WALSH BAY ARTS & CULTURAL PRECINCT

HERITAGE IMPACT STATEMENT

SSD 8671

Modification 7

Figure 3: West elevation of Wharf 4/5 – Replacement of existing FC panels with louvres to Level 1.

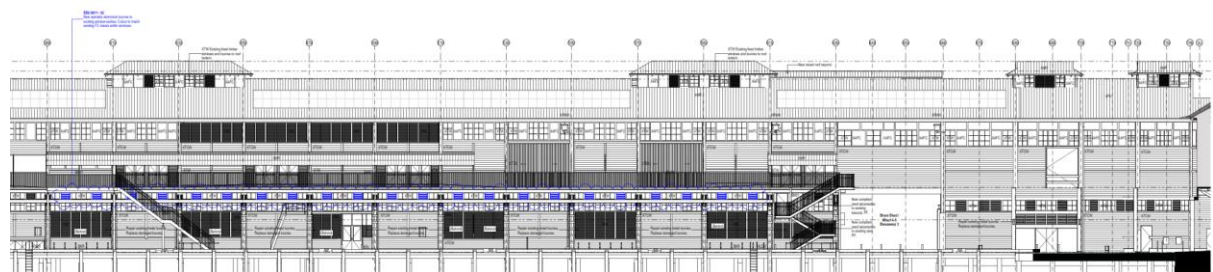
The projection of the wharf into the harbour has exposed the building to extreme weather, in particular rain and wind. Rainwater has been blown into the building through the existing glazed louvres along the western corridor on Level 1 (Figure 7). These existing glazed louvred openings (previously approved SSD8671) that facilitate smoke relief will be shut to prevent rainwater from entering the building.

Due to the reduction of the overall smoke relief area, RCC have informed that additional louvred openings will be necessary to meet the required area for smoke relief.

The proposal involves replacing 10 existing FC (asbestos) panels at high level with new fixed open, two stage aluminium powdercoated louvres (Figures 8 and 9).

The proposal has been discussed with City of Sydney heritage specialist. Based on their advice, the proposed louvres must be painted to match the colour of the existing FC panels. This is to mitigate any visual impact and maintain the consistency of the overall appearance and regular façade pattern of the wharf.

- New solid louvres must match colour of existing FC panels.
- Removal of existing FC panel must be carried out with care to minimise impact to adjacent heritage fabric.
- Installation of new louvres must be carried out with care with no/minimal heritage fabric intervention.
- Mechanism for operable louvres must be rationalised and avoid fixing into existing heritage fabric.
- If any fixings are required into heritage fabric, they must be minimised to allow reversibility. Heritage Consultant must be notified.

Figure 4: West elevation of Wharf 4/5 – Replacement of existing FC panels with louvres to Ground Floor.

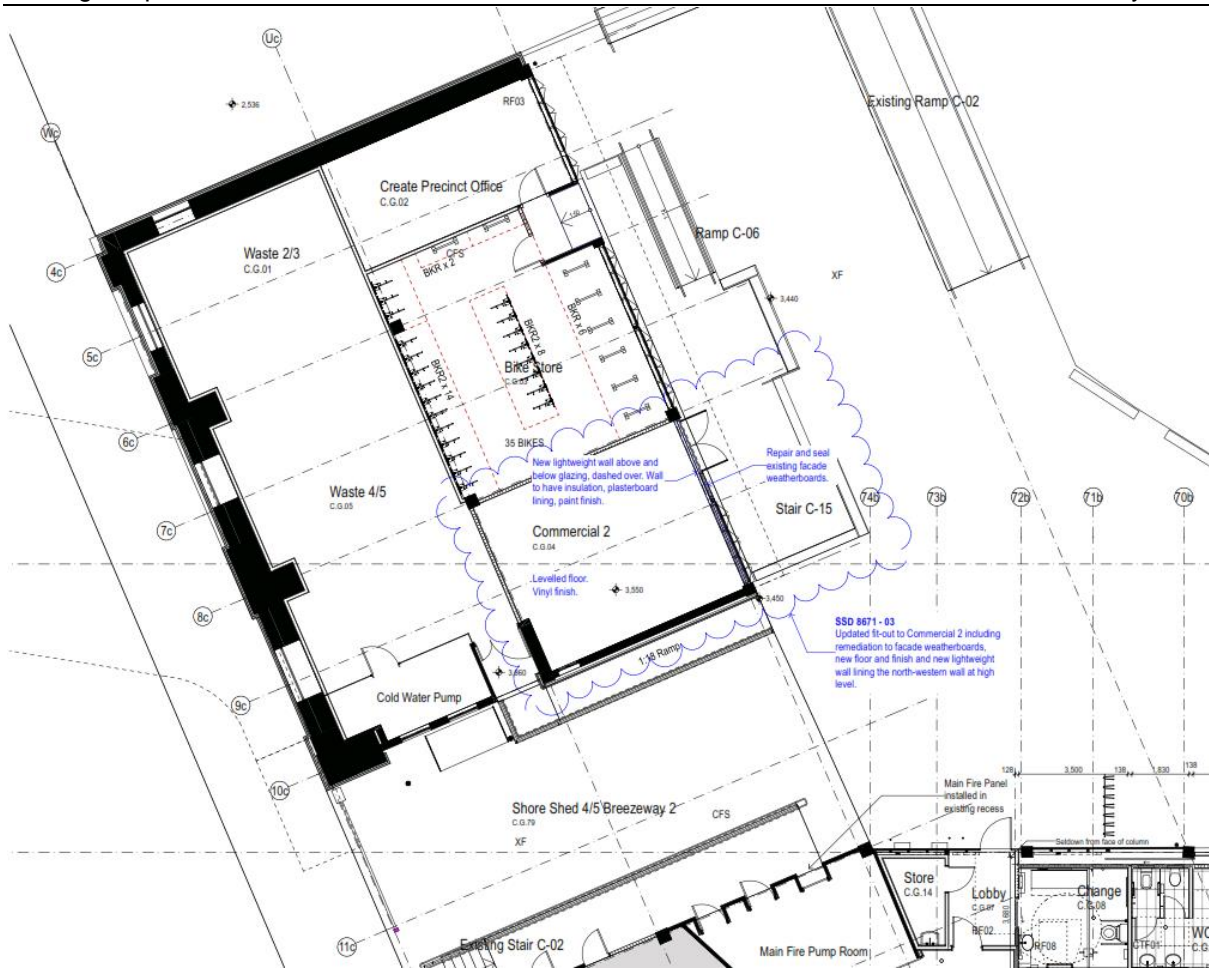
The proposed louvres are located at high level to the dance studios on the Ground Floor, at the western façade of Wharf 4/5.

The current dance studios are not air conditioned and they rely generally on good natural ventilation with the help of fans and louvres. Occupants of the dance studios have expressed discomfort during warm to hot external conditions that caused the temperatures within the studios to increase beyond acceptable. Options were investigated by the mechanical consultant and included the introduction of air conditioning, and the increase of passive cooling and ventilation within the space.

The introduction of air conditioning to the dance studios was deemed not feasible as it will require additional power which exceeded the current electrical demand of the site. The only reasonable alternative will be to vent the hot air out from the spaces through increased fan speed and additional louvres.

The proposed modification includes increasing the number of louvred openings to the façade to allow more hot air to be naturally vented out via increased fan speed and evaporative cooling.

The proposal involves replacing 22 existing FC (asbestos) panels with new operable aluminium powder coated louvres and frame.

The proposal has been discussed with City of Sydney heritage specialist. Based on their advice, the proposed louvres must be painted to match the colour of the existing FC panels. This is to mitigate any visual impact and maintain the consistency of the overall appearance and regular façade pattern of the wharf.

Figure 7: Level 1 western corridor.

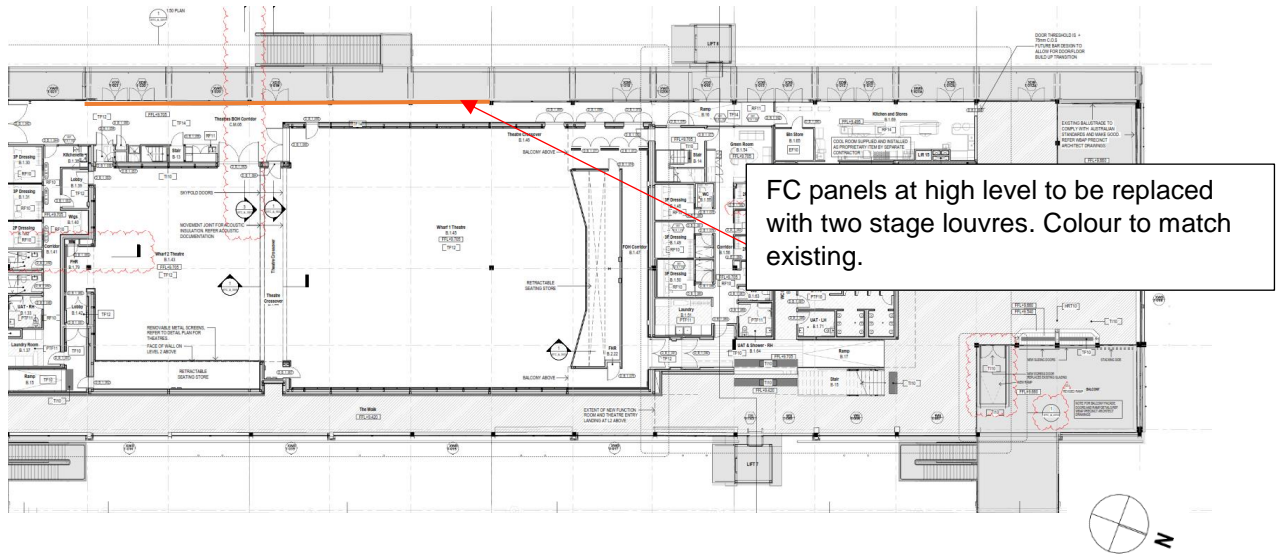
Existing glazed louvred opening to be shut to prevent rain water from entering the building.

Figure 20: Previously approved proposal for Commercial 3 and 4.

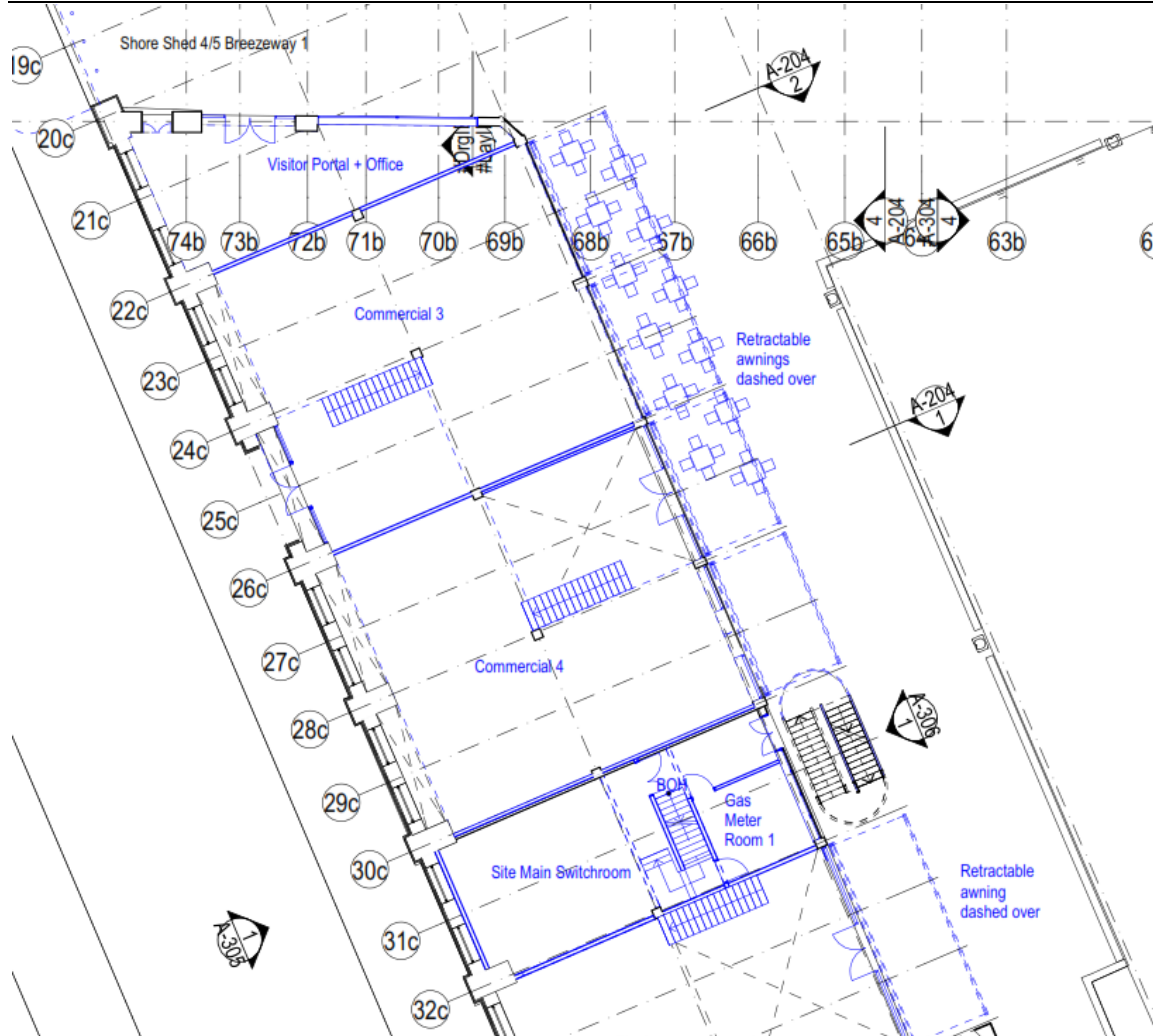
Further, this proposed design modification to Commercial 3 can be considered less intrusive compared to the previous SSD approval which included a staircase and mezzanine level (Figure 20). Refer Section 3.0 and Section 4.0 for heritage impact assessment and heritage recommendations.

Figure 22: Southern brickwall to Commercial 3. Note lower section previously chased for services and damaged brick face where previous tiles removed

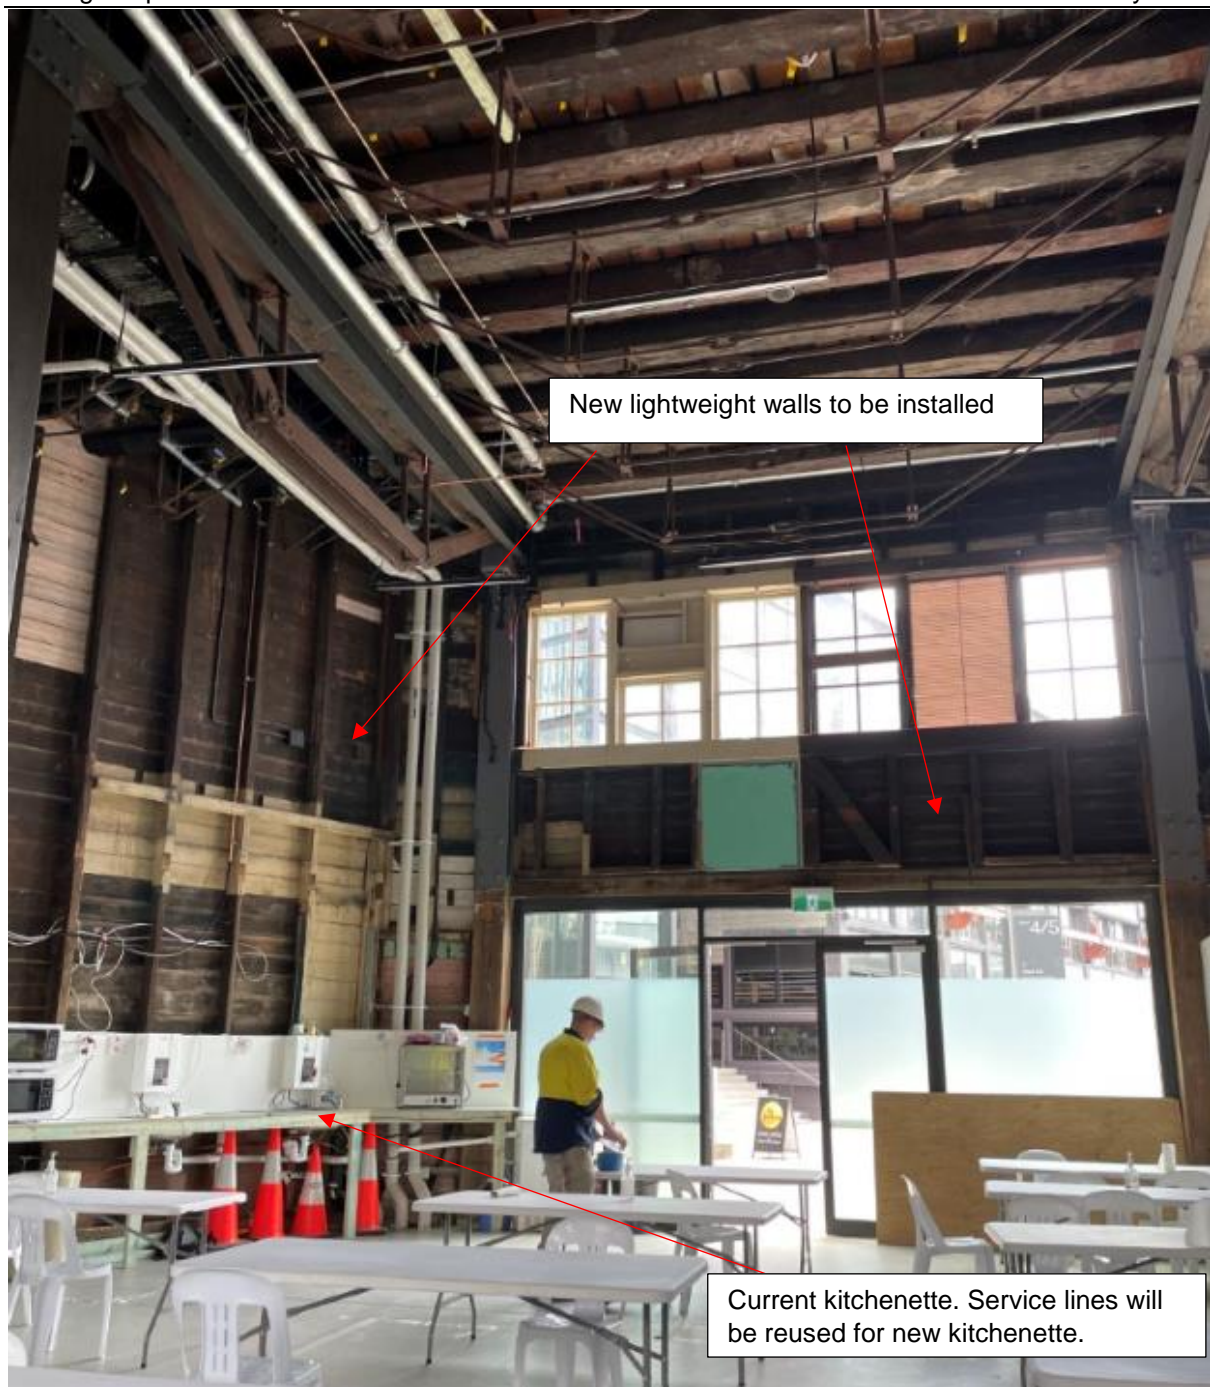
Note: The proposed plasterboard lining will be fixed to a new steel stud frame to the southern brick wall. This is where the previous toilet services were chased into the brick wall and wall tiles fixed to the brickwork. The new plasterboard wall is considered a less intrusive approach to cover previous unsightly damage where services and tiles have been removed and where poor cement mortar patchwork has been carried out (Figures 22 and 23). The plasterboard sheeting is necessary to create a safe wall surface and avoid further damage to the early significant brick wall.

- Sealing and painting of existing weatherboard façade must be carefully carried out. Application of sealant must be neat and consistent. This is to limit further impacts to heritage fabric and maintain a weatherproof and consistent appearance.
- Carefully clean brick surface in order to remove dirt, debris and harmful substances.
NOTE: No harsh chemicals are to be used.
- Where repointing or making good to existing face work are necessary, match sound original brickwork and joints as determined by examination and matching of adjacent areas.
- No new chasing to brick wall is permitted.
- Any new fixings must be to mortar joints.

- New plasterboard lined wall to be set below window sill by approximately 3 bricks to allow interpretation of window sill and max exposure of undamaged brickwork. This will also interpret previous wall tiling to wet area.
- New steel framing is to be fixed to existing timber framing with minimal screw fixings at maximum centres. This is to minimise any damage to existing timber fabric, and allow reversibility.
- Existing storey posts must be kept exposed. Painting of timber storey posts is not permitted unless previously painted.
- Wherever possible, expose timber structural members (beams and bracing) and retain natural finish.
- New kitchenettes are to reuse existing service points.
- New service points in particular new plumbing to other areas are not permitted.
